## New functions and addendum

This document contains descriptions of how to set the new functions and their restrictions of WV-V1170. It is recommended to read them while referring to the Operating Instructions provided with this product together.

### ·Firmware Ver.2.61

## 2. PTZ Setting

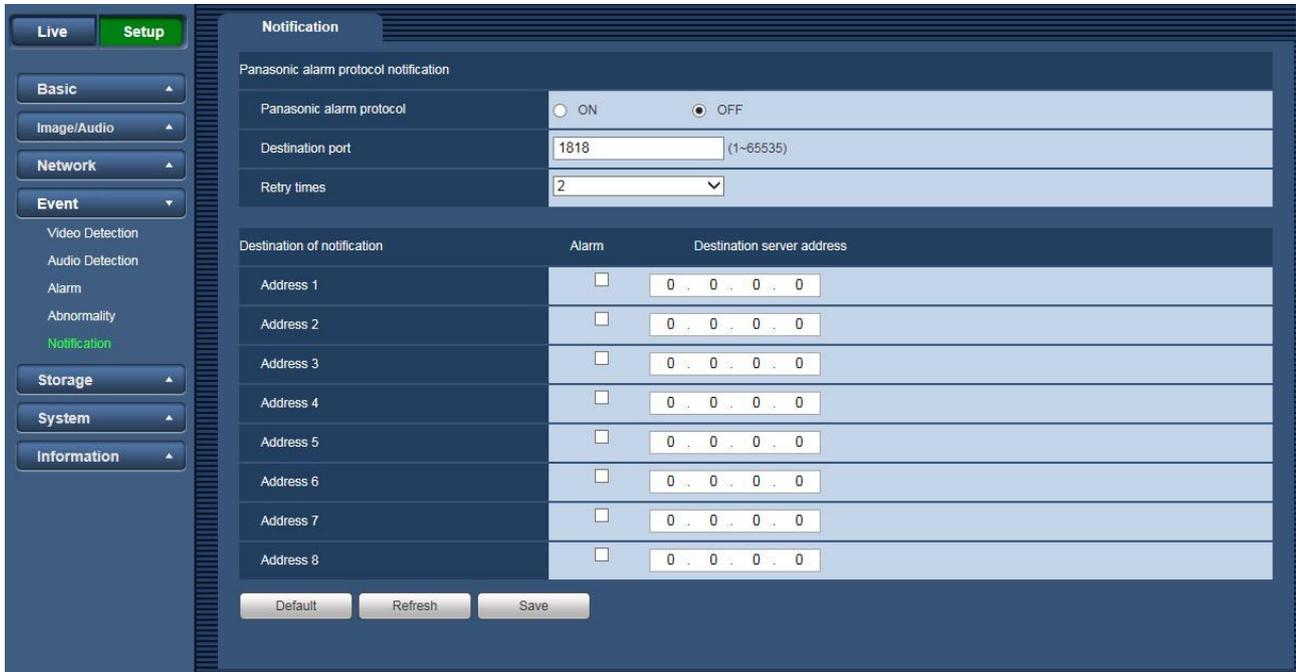
Add RS485 operation setting on PTZ setting menu.

RS485 operation:  ON(PTZ)  OFF

<b>RS485 operation</b>	<p>Determine whether or not to display items related to RS485 transmission on the “Live” page.</p> <ul style="list-style-type: none"><li>- ON(PTZ): Displays a screen and PTZ button that uses RS485 transmission to control the pan/tilt head.</li><li>- OFF: Does not display items related to RS485 transmission.</li></ul> <p>Default: OFF</p>
------------------------	----------------------------------------------------------------------------------------------------------------------------------------------------------------------------------------------------------------------------------------------------------------------------------------------------------------------------------------------------
